CONSTRUCTION PLAN

DELAWARE DEPARTMENT OF TRANSPORTATION	ADDENDUMS / REVISIONS	SCALE 0 30 60 90 FEET	I-95 & US 202 INTERCHANGE	CONTRACT T200510602	BRIDGE NO. NA	CONSTRUCTION DETAILS CD 3 OF 14	SHEET NO. 157
	△2 REVISED DETAIL TITLE AND NOTE			COUNTY NEW CASTLE	DESIGNED BY: TM		TOTAL SHTS. 482
					CHECKED BY: MAA

DELAWARE DEPARTMENT OF TRANSPORTATION	ADDENDUMS / REVISIONS	SCALE 0 30 60 90 FEET	I-95 & US 202 INTERCHANGE	CONTRACT T200510602	BRIDGE NO. NA	CONSTRUCTION DETAILS CD 4 OF 14	SHEET NO. 158
	△ REVISED DETAIL TITLE			COUNTY NEW CASTLE	DESIGNED BY: TM		TOTAL SHTS. 482
					CHECKED BY: MAA

TYPICAL MEDIAN INSTALLATION

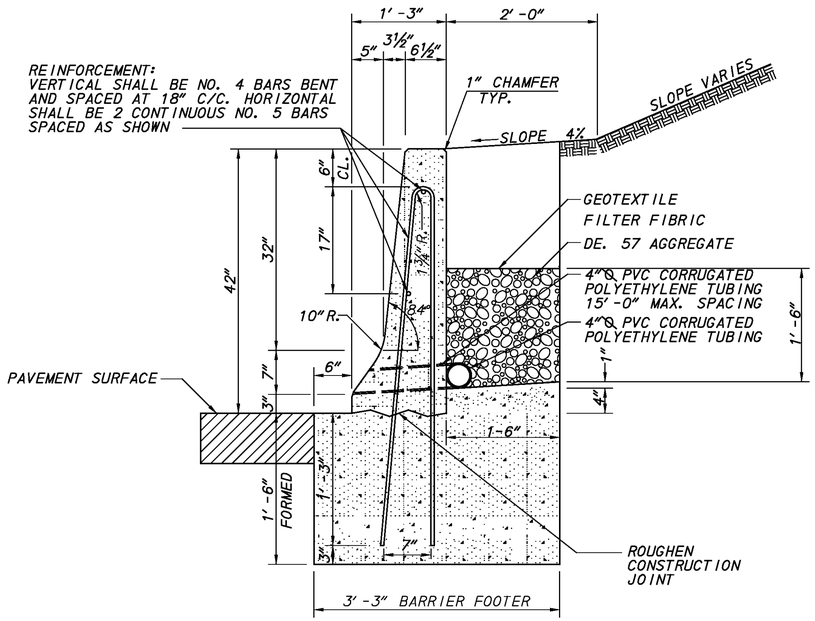
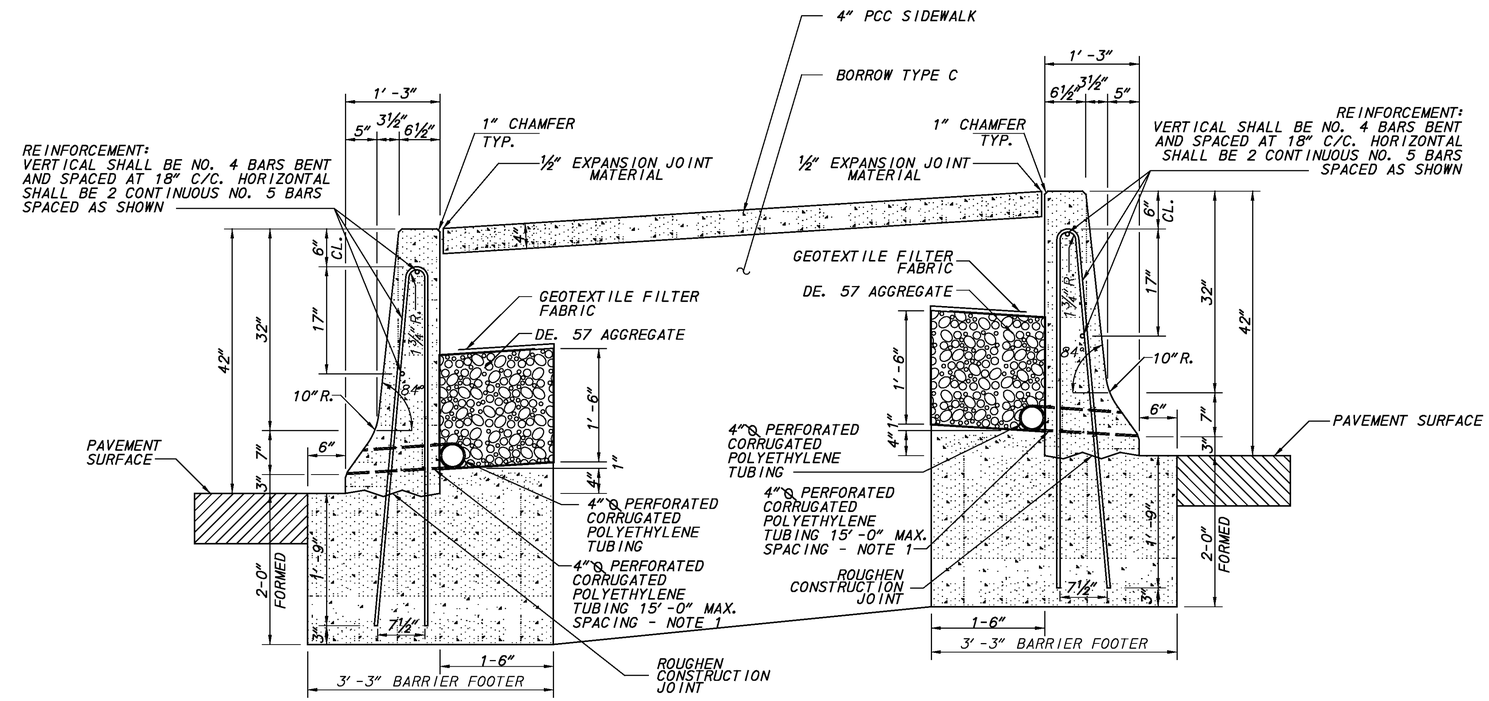
△2 PCC SAFETY BARRIER PERMANENT, SINGLE FACE (ITEM 720550)

~~PCC BARRIER, MODIFIED (720550)~~

DRAINAGE INLET DETAIL AT BARRIER

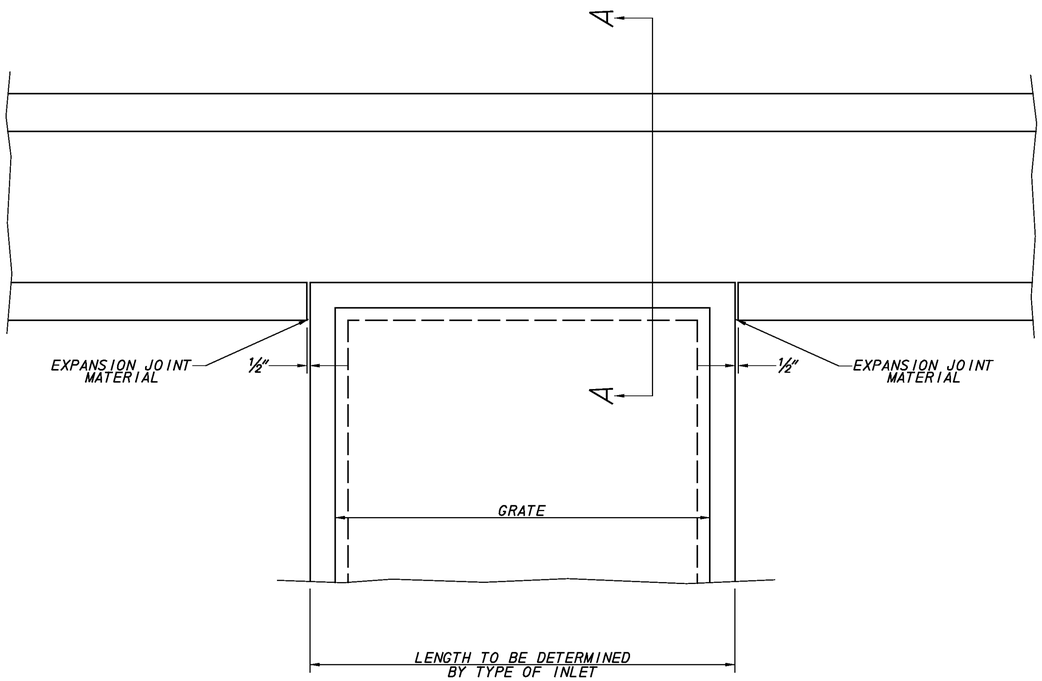
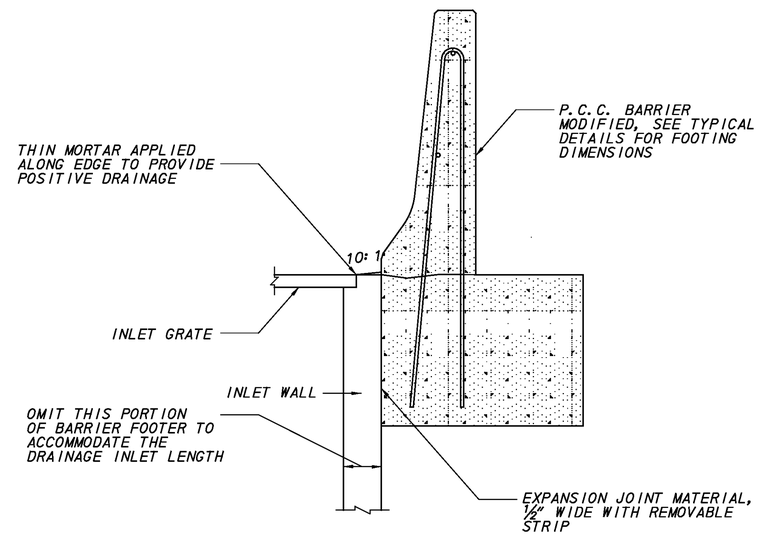
△ PCC SAFETY BARRIER PERMANENT, SINGLE FACE (ITEM 720550)

~~PCC BARRIER, MODIFIED (720550)~~

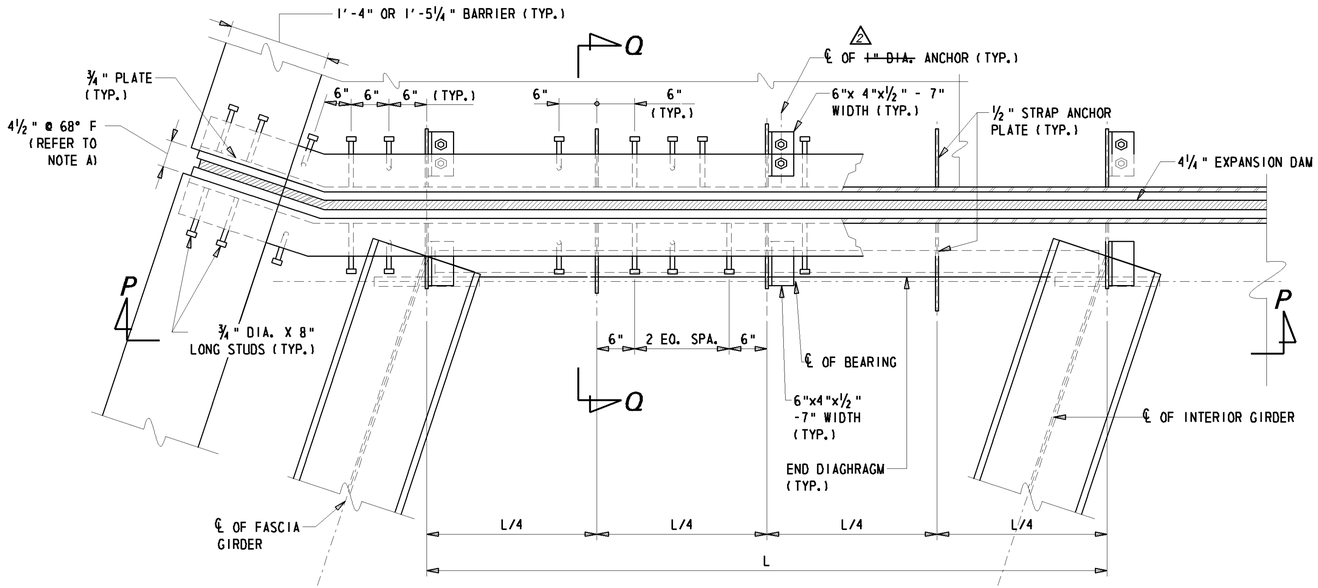
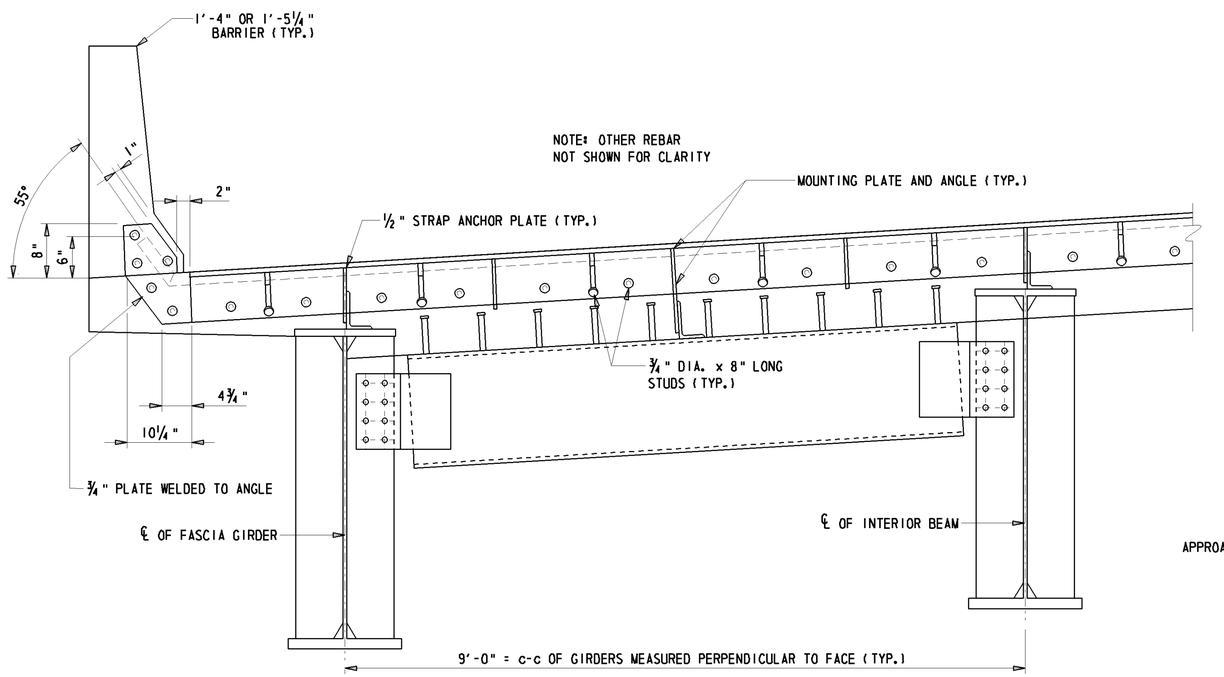
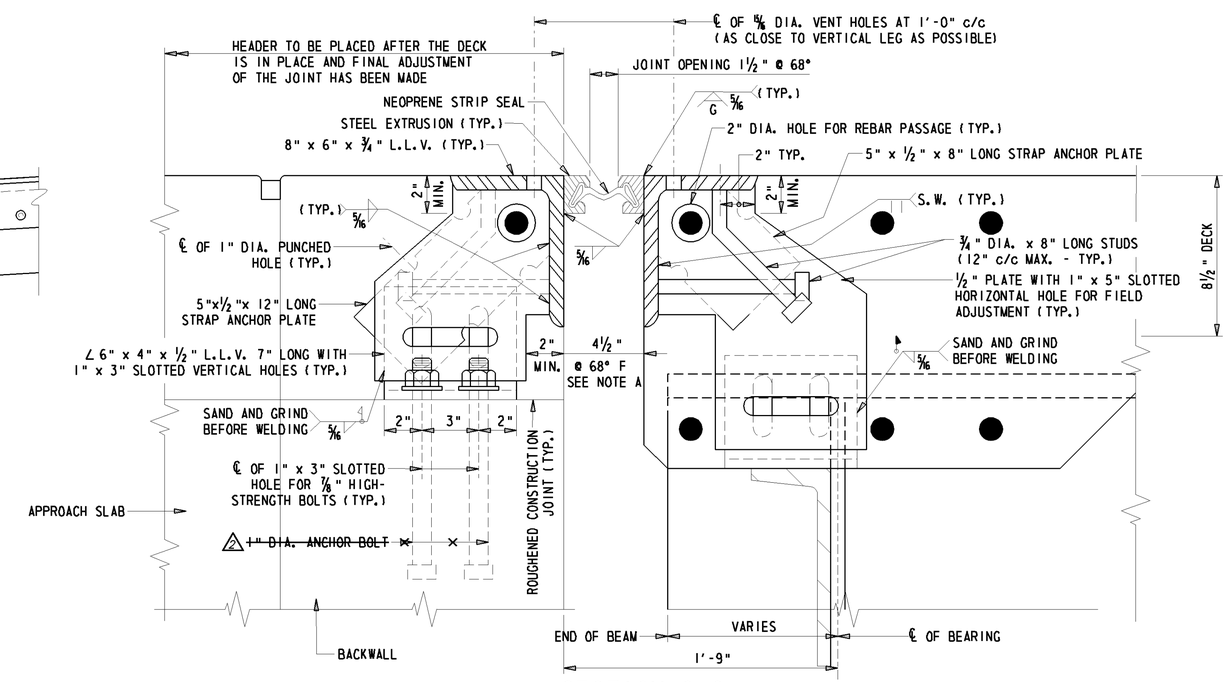
DELAWARE DEPARTMENT OF TRANSPORTATION	ADDENDUMS / REVISIONS 2 - DELETED CONFLICTING DIMENSIONS, JKM 7/26/11	**I-95 & US 202 INTERCHANGE**	CONTRACT T200510602	BRIDGE NO. **1-762**	**EXPANSION JOINT DETAILS S2 – 16 OF 18**	SHEET NO. 184
			COUNTY NEW CASTLE	DESIGNED BY: JKM CHECKED BY: BAB		TOTAL SHTS. 482

NOTE A:
THE CONTRACTOR SHALL ADJUST THE OPEN DECK JOINT AS REQUIRED BY THE WIDTH OF THE STEEL EXTRUSION USED SO AS TO PROVIDE A 1½" JOINT OPENING AT 68°F.

ABUTMENT B FOOTING PLAN

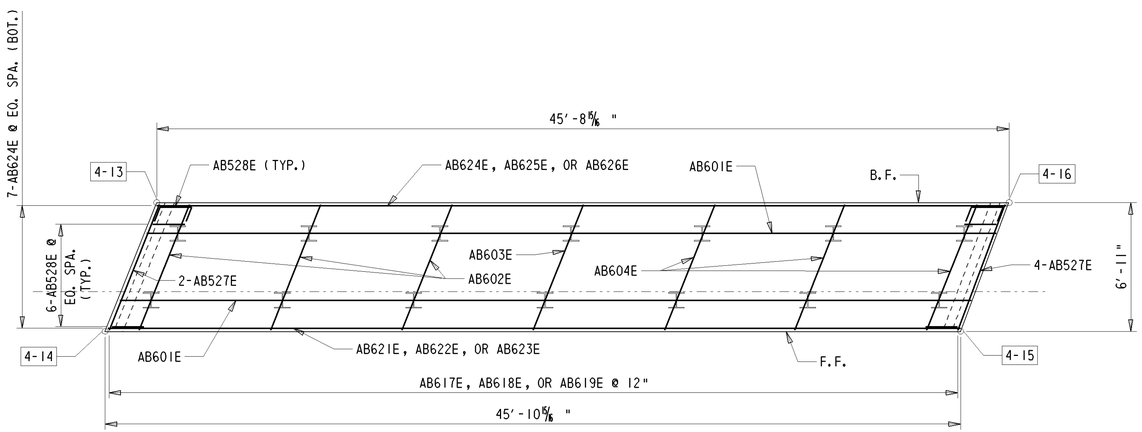
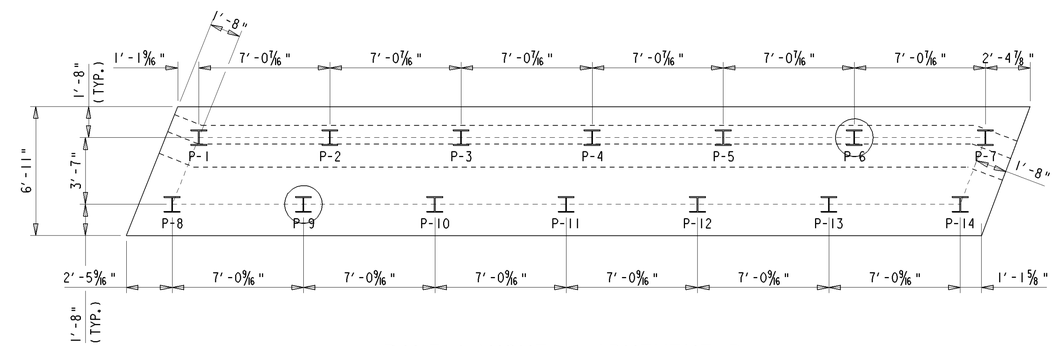
△2 REVISED CONFLICTING NOTE, MJG 7/29/11

△2 PILES SHALL BE INSTALLED AT THE CENTER OF THE PIPES AFTER THE QUARANTINE PERIOD OF 30 DAYS. QUARANTINE PERIOD BEGINS ONCE THE MSE WALLS HAVE BEEN BROUGHT UP TO PROPOSED GRADE.

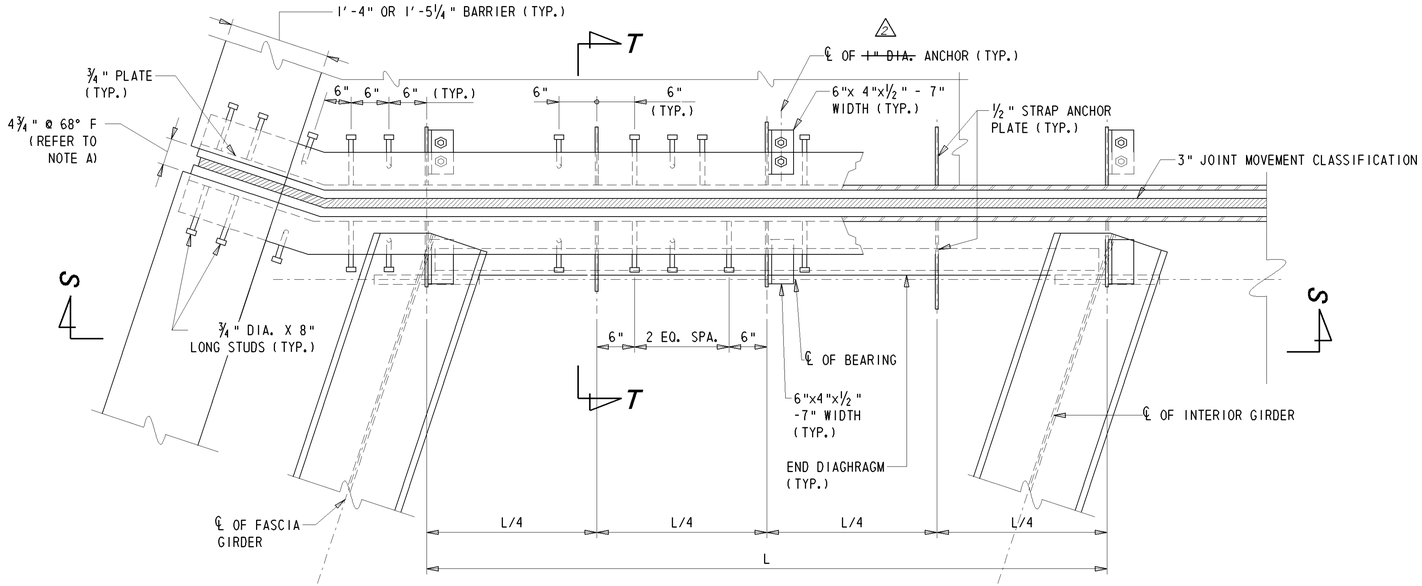
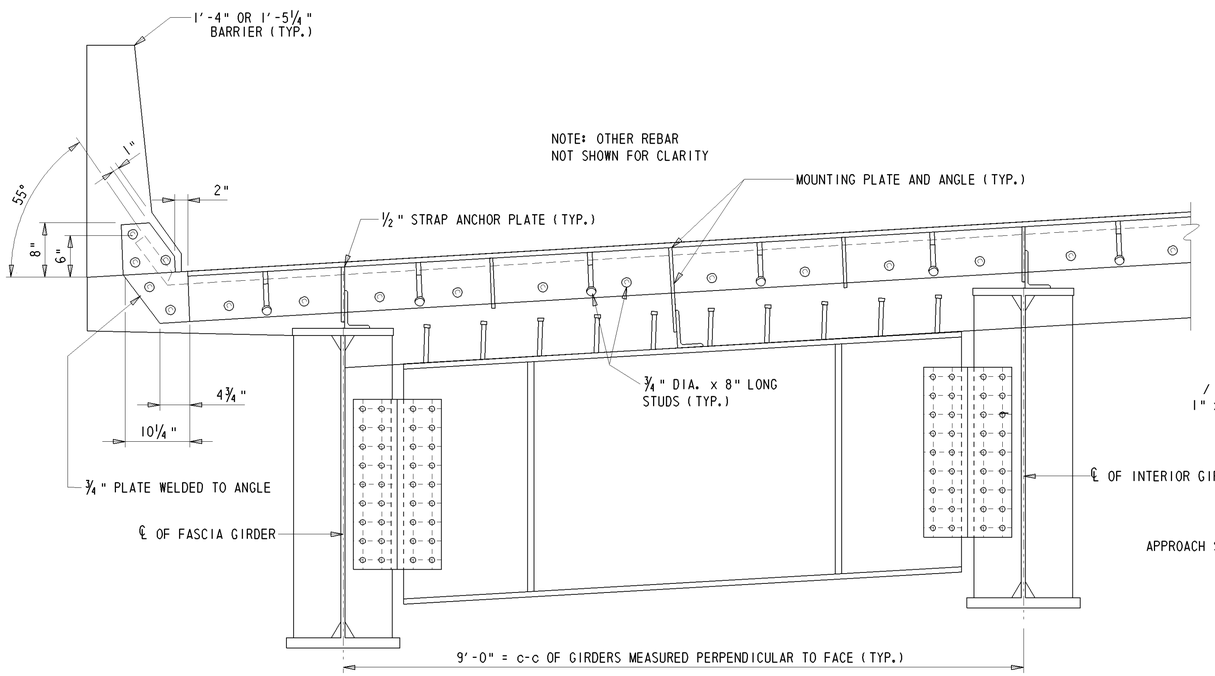
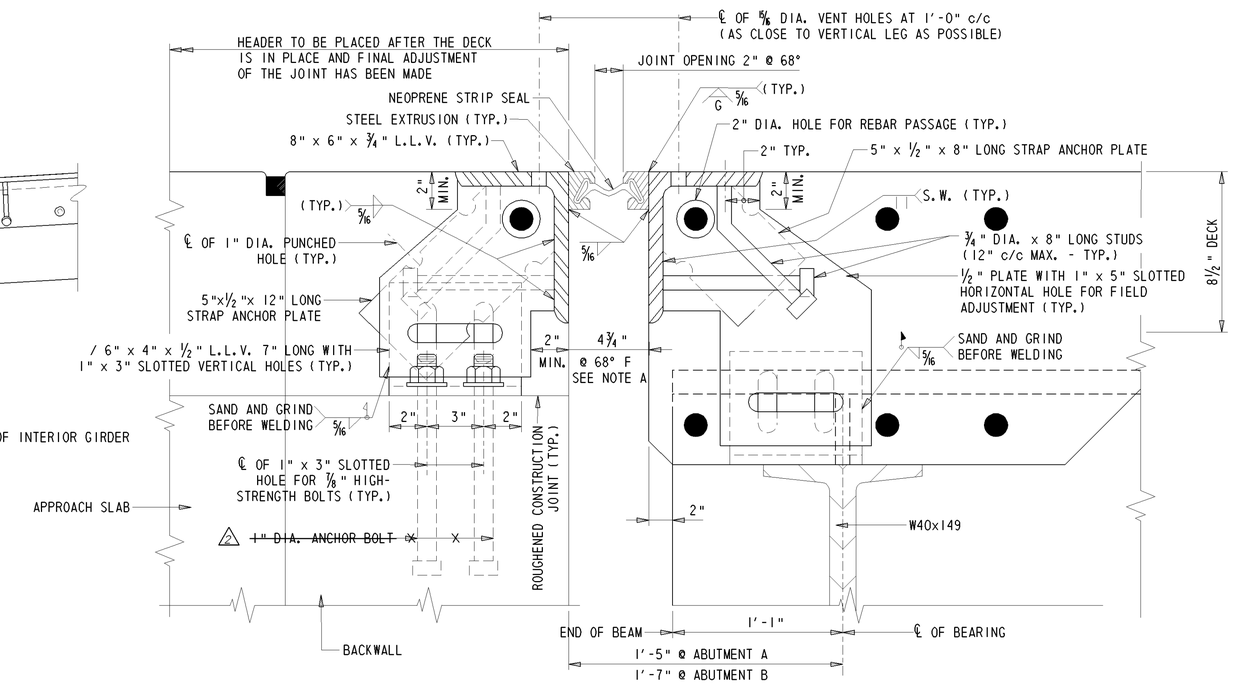
DELAWARE DEPARTMENT OF TRANSPORTATION	ADDENDUMS / REVISIONS △2 - DELETED CONFLICTING DIMENSIONS, MJG 7/26/11	**I-95 & US 202 INTERCHANGE**	CONTRACT T200510602	BRIDGE NO. **1-764**	**EXPANSION JOINT DETAILS S4-20 OF 23**	SHEET NO. 206
			COUNTY NEW CASTLE	DESIGNED BY: MJG CHECKED BY: JNH		TOTAL SHTS. 482

NOTE A:
THE CONTRACTOR SHALL ADJUST THE OPEN DECK JOINT AS REQUIRED BY THE WIDTH OF THE STEEL EXTRUSION USED SO AS TO PROVIDE A 2" JOINT OPENING AT 68°F.

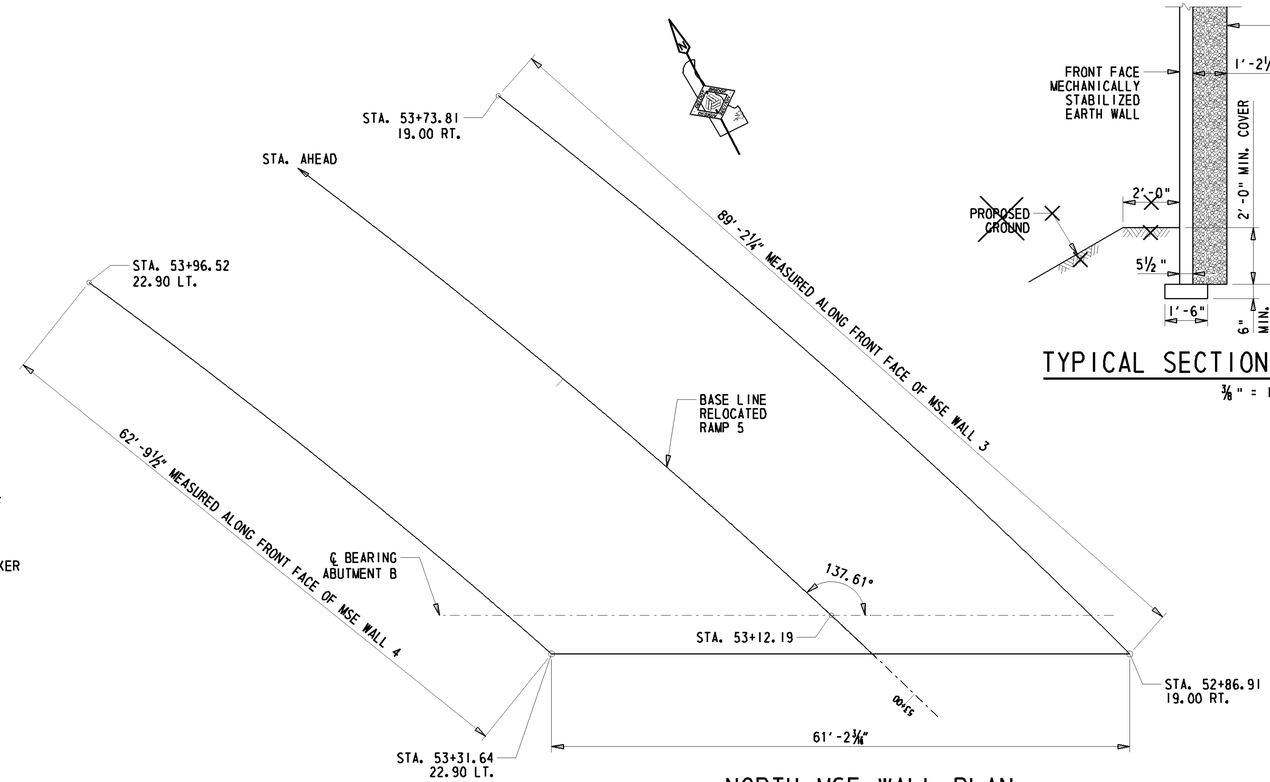
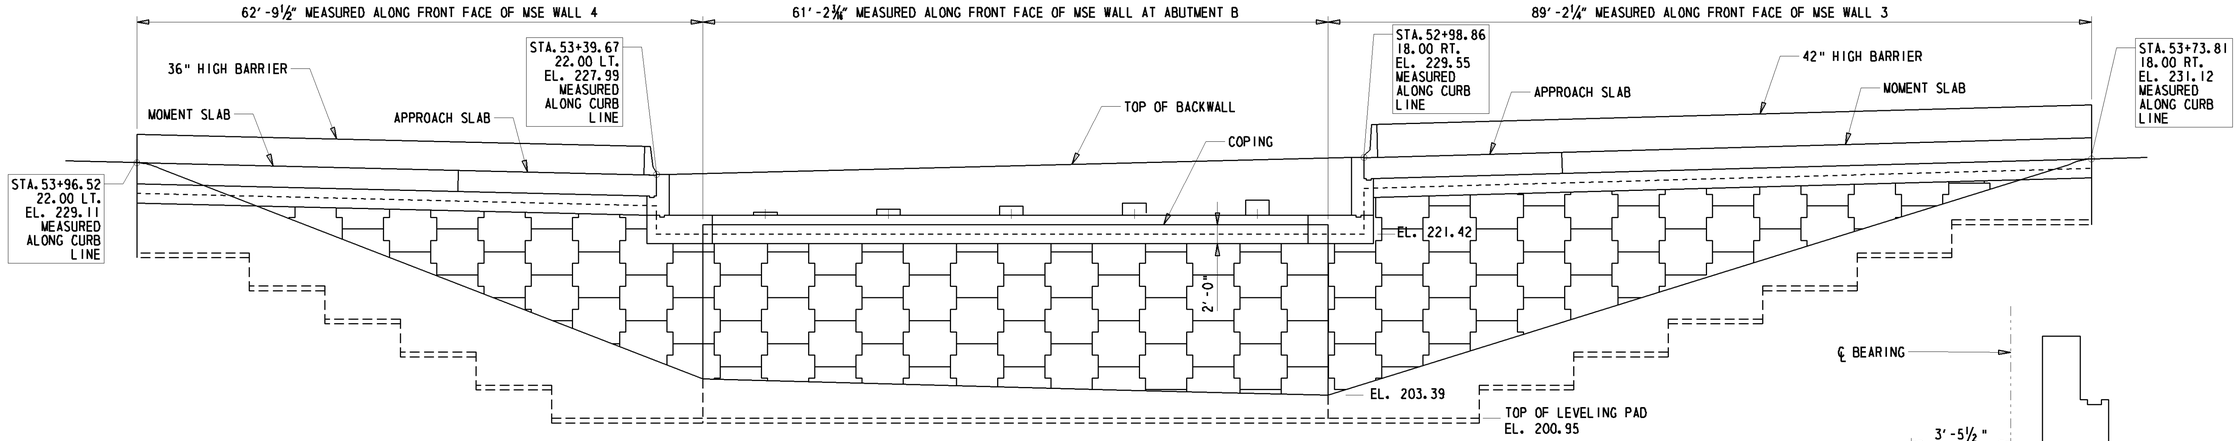
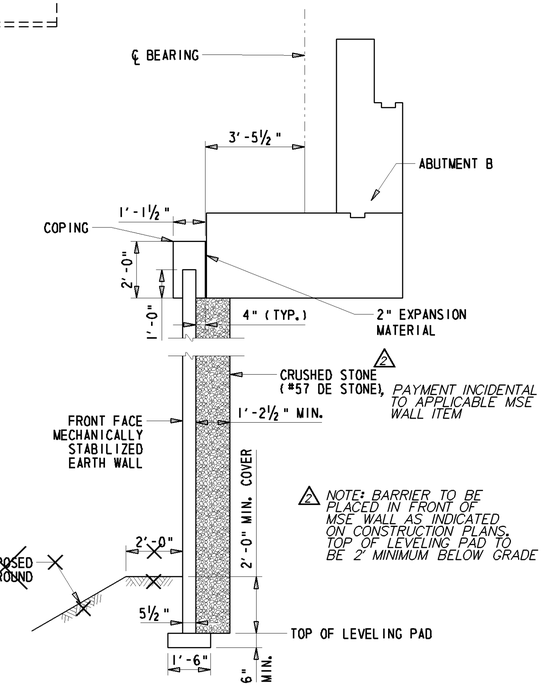
DELAWARE DEPARTMENT OF TRANSPORTATION	ADDENDUMS / REVISIONS 2 - DELETED CONFLICTING DETAIL, ADDED NOTE, TRS 7/29/11		**I-95 & US 202 INTERCHANGE**	CONTRACT T200510602 COUNTY NEW CASTLE	BRIDGE NO. 1-763 DESIGNED BY: TRS CHECKED BY: JNH	**MSE WALL 3 & 4 DETAILS S3 – 5 OF 19**	SHEET NO. 214 TOTAL SHTS. 482

NOTE: REINFORCEMENT FOR MSE WALL SHALL BE SKEWED TO AVOID PILES.
